**Historic Preservation Services**

**REPORT OF ALTERATIONS TO DESIGNATED RESOURCE**  
**Site Number/Address: 321 E. Olive Street**  
**Laurel School National Register Historic District**  
**ISSUED: October 18, 2021**

This report is to document proposed alterations to the C.S. Miner/Groshong Residence at 321 E. Olive Street, pursuant to Fort Collins Municipal Code Chapter 14, [Article IV](#). A copy of this report may be forwarded to the Colorado Office of Archaeology and Historic Preservation.

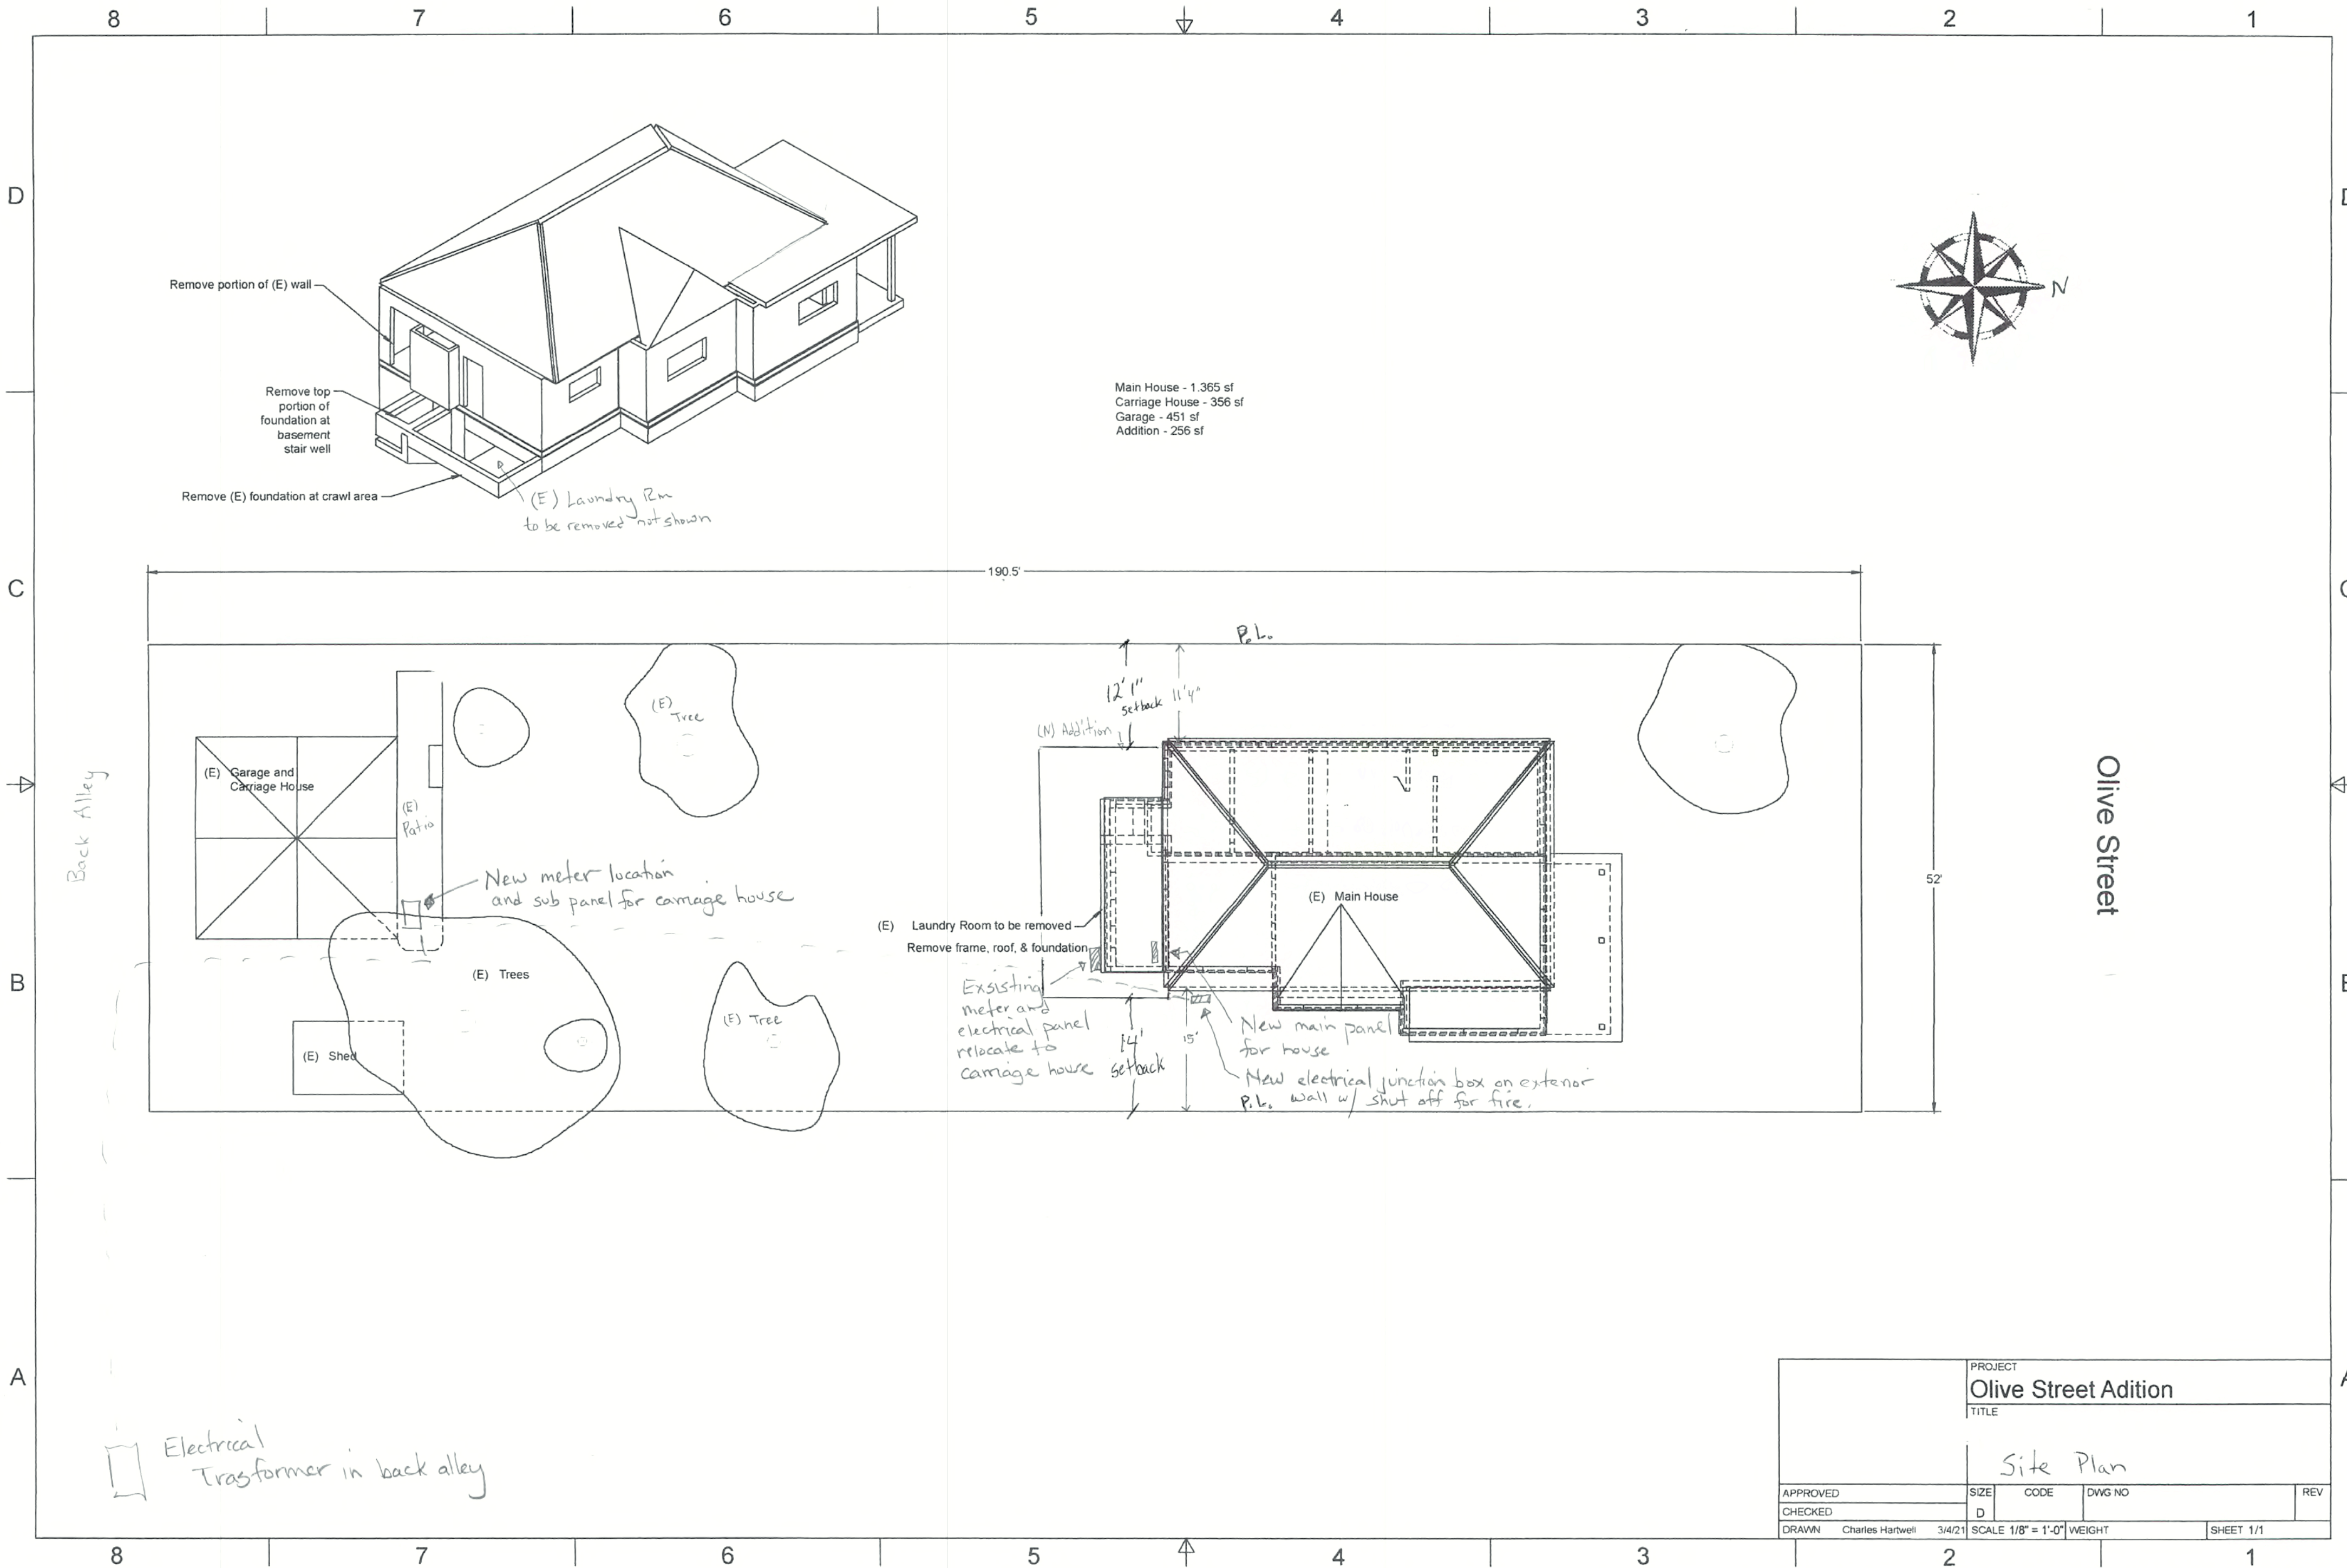
An historic survey completed in 1995 shows the property mostly in the same condition as it is presently:

The rear porch, while apparently an original feature to the residence, has been modified significantly over time and no longer reflects its likely historic appearance. It is not a character-defining feature and its demolition does not conflict with this Standard. The new porch is located on the rear and will not features, spaces, or spatial relationships that define the property. This project meets this Standard.

PROJECT				
Admin Project				
Plan and Elevations				
APPROVED	SIZE	CODE	DWG NO	REV
CHECKED	D			
DRAWN	Charles Hartwell	3/4/21	SCALE 1/4" = 1'-0"	WEIGHT
				SHEET 1/1

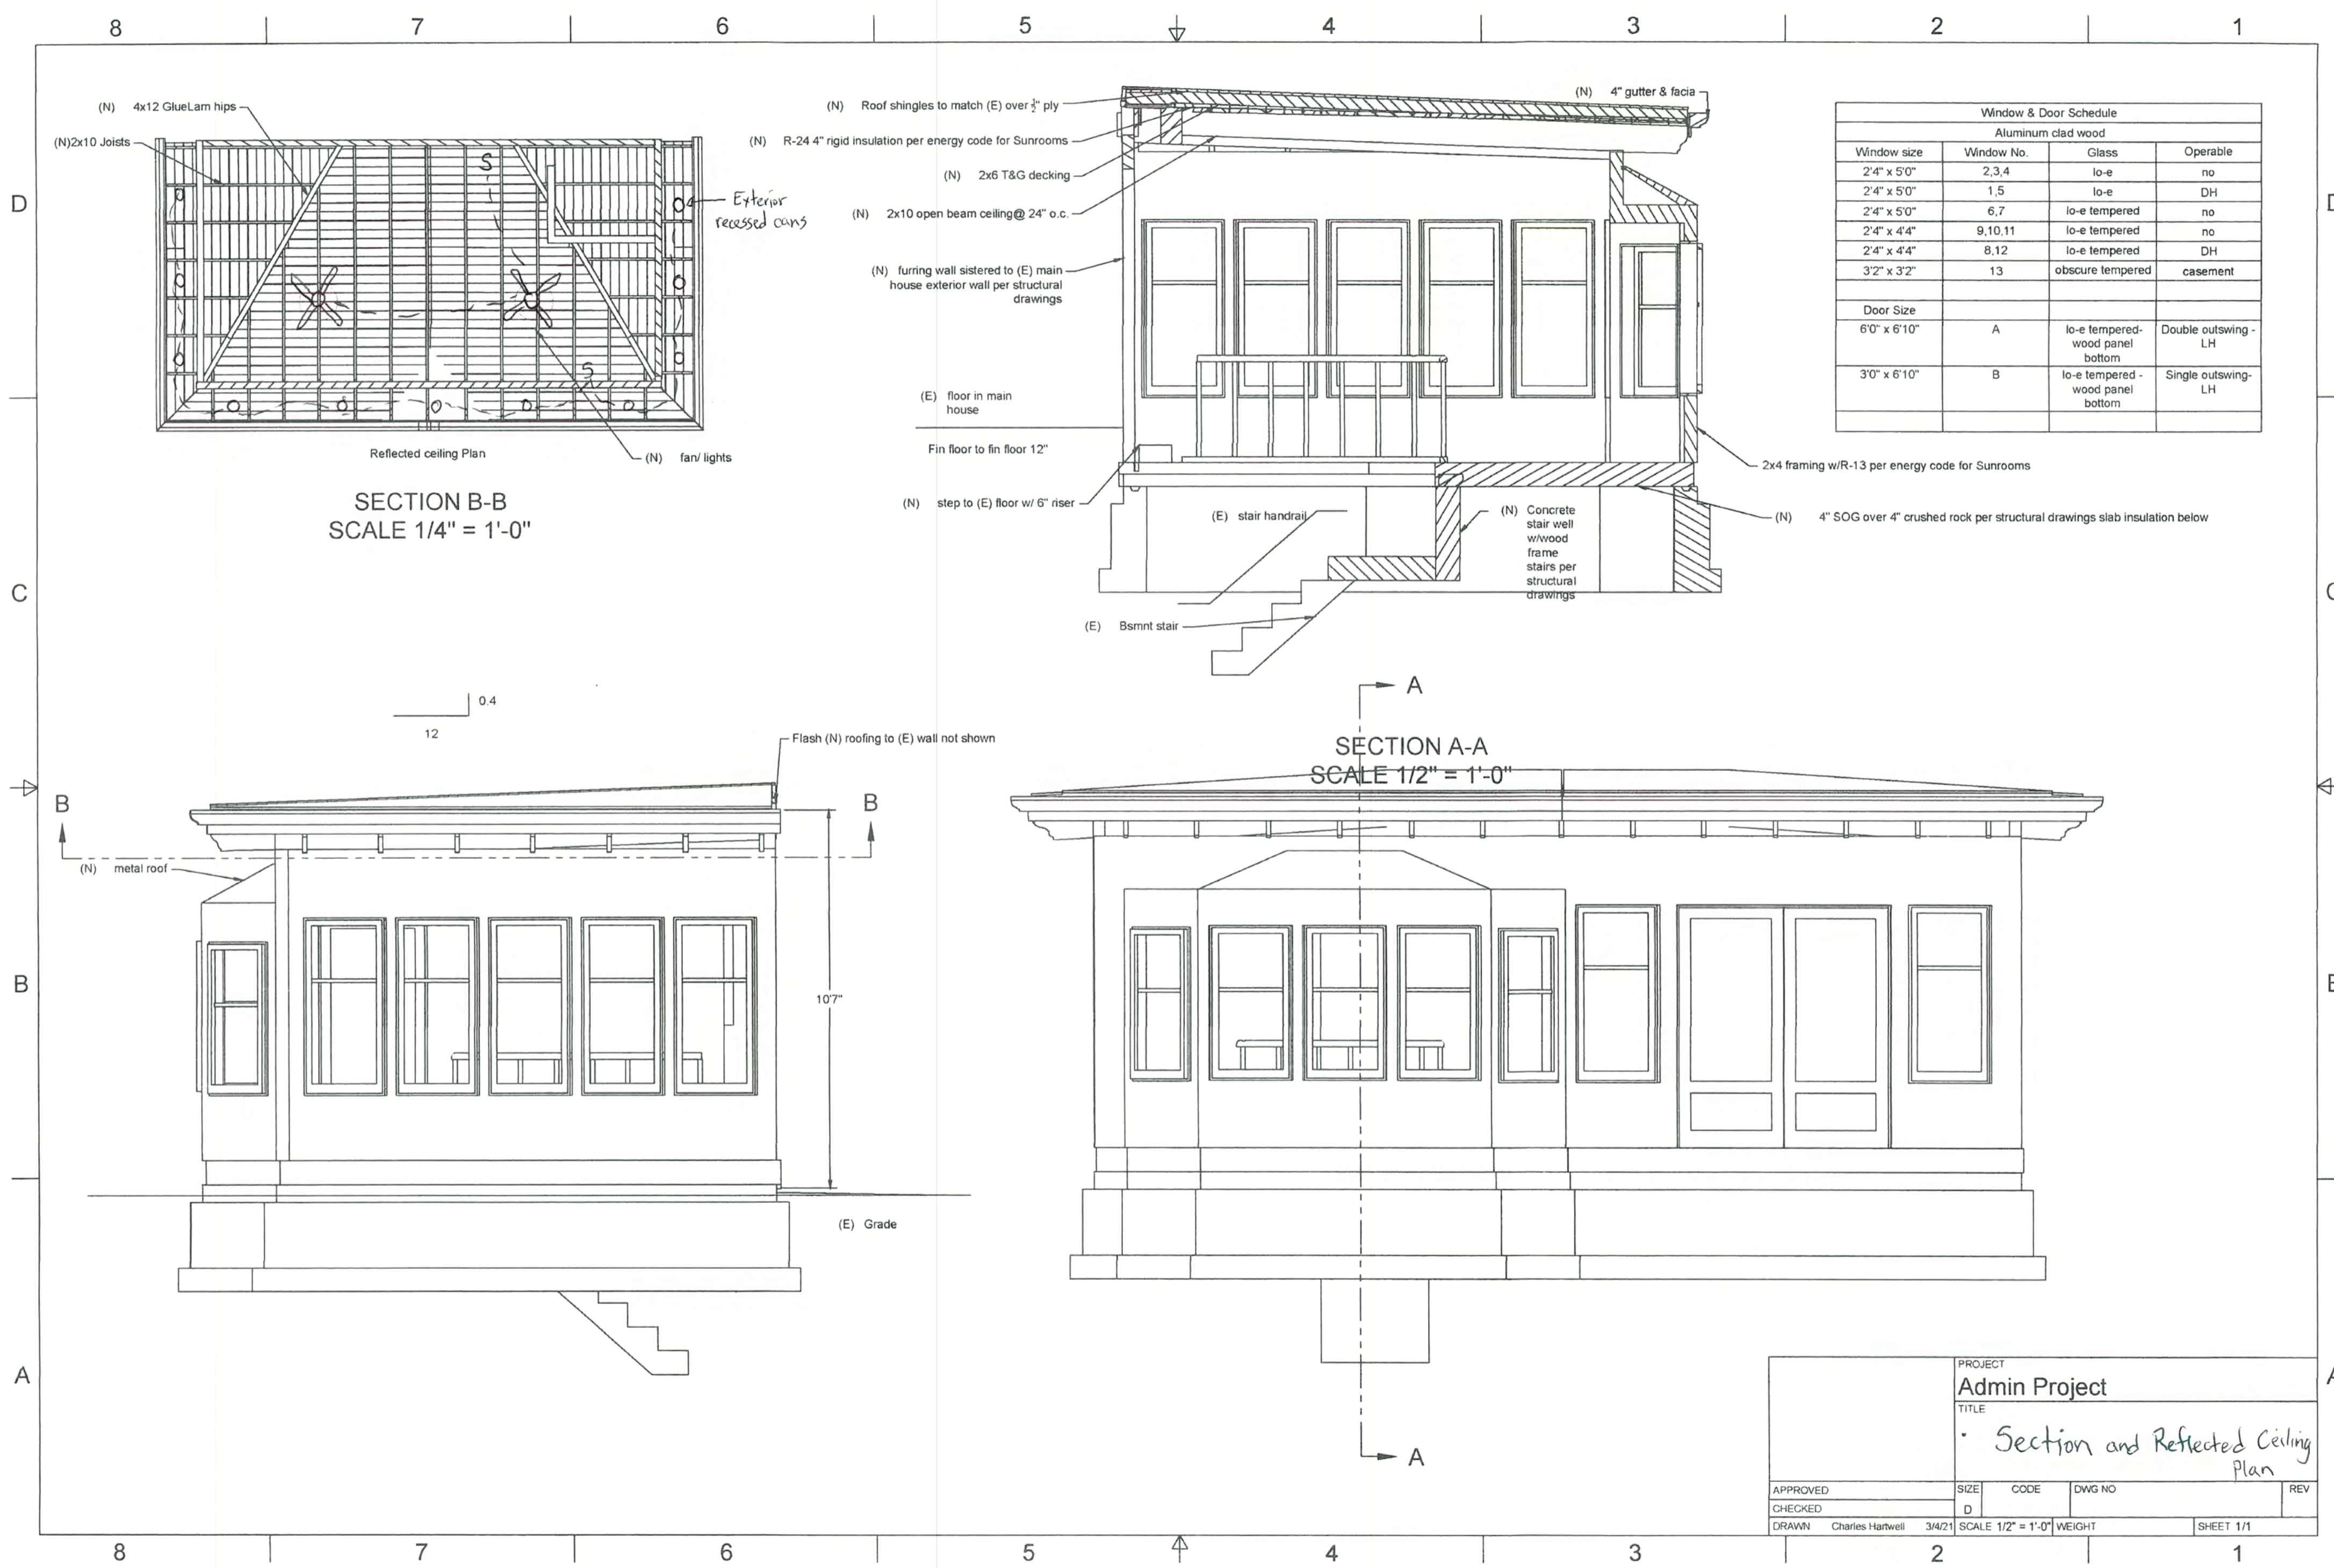
The proposed new rear porch reflects common elements of Victorian-style porches in overall massing and fenestration pattern but includes elements not normally on such a feature to help reflect its status as new construction, including paired rear

<p>exit doors and a stone veneer below the window sills. However, the differentiation of the new rear porch could be improved by simplifying other decorative details, including potentially replacing the sash windows with single-light casements.</p>	
SOI #4	<p><i>Changes to a property that have acquired historic significance in their own right will be retained and preserved.</i></p> <p><b>Research into building permit records found the following history of alterations at the property:</b></p> <ul style="list-style-type: none"> <li>- <b>1903</b> – main house and rear barn constructed; 1906 Sanborn map shows main house in current configuration, including rear porch</li> <li>- <b>1931</b> – repair barn damaged by fire</li> <li>- <b>1949</b> – add insulation</li> <li>- <b>1951</b> – wire fence added</li> <li>- <b>2003</b> – garage constructed w/ 264 ft<sup>2</sup> loft (barn presumably demolished at this time or before)</li> <li>- <b>2007</b> – garage upstairs adapted to living space (410 ft<sup>2</sup>)</li> <li>- <b>2005</b> – reroof</li> <li>- <b>2019</b> – reroof house &amp; garage</li> </ul> <p>As noted above, the existing rear porch is original to the house but has been heavily modified since construction. While conservation of building materials is encouraged, no significant historic features are being removed.</p>	Y
